TO: **Amy Hodgen (Statutory Planning)**
FROM: **Blake Farmar-Bowers (Open Space) and
Christian Lundh (Urban Design)**
DATE: 2 June 2020
SUBJECT: 81 La Trobe Avenue, Alphington
APPLICATION NO: PLN19/0841
DESCRIPTION: Construction of residential development in Precinct 3A (Artisan West) of the Alphington Paper Mills development comprising dwellings, vehicle access, car parking, public accessible private landscape areas, roof top terraces and vertical greenery.

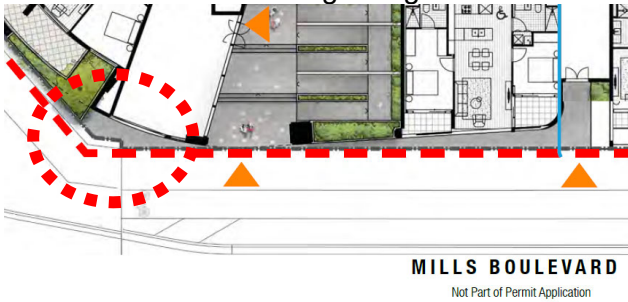
- Provide detailed cross sections showing the full length from back of kerb. Provide sections at a minimum as indicated with red lines on screenshot below.
- Also provide a landscape elevation, accurately show the landscaped interface (planter boxes) along the frontage.

- Confirm pavement / treatment of the sliver of land between the planterboxes / site boundary and the SUP, highlighted in streetview image below.

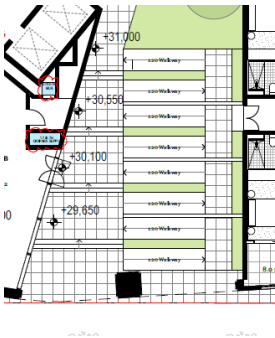
- What is the use/purpose of the area by the corner Chandler Hwy and Mills Blvd, highlighted below?
- Would there be potential to have a planter box in this area, to mitigate the risk of it becoming 'dead zone' / litter trap?
- Show levels and grading and extent of any required retaining walls or edges.

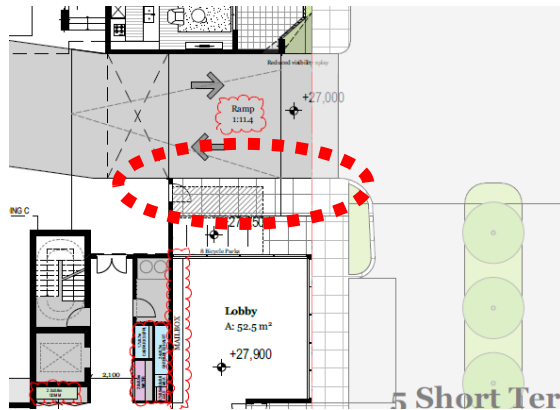
- Artisan East plans prepared by DKO from December 2019 shows stair with different orientation, refer below left. Confirm that the configuration shown in this application to the right is the final configuration.
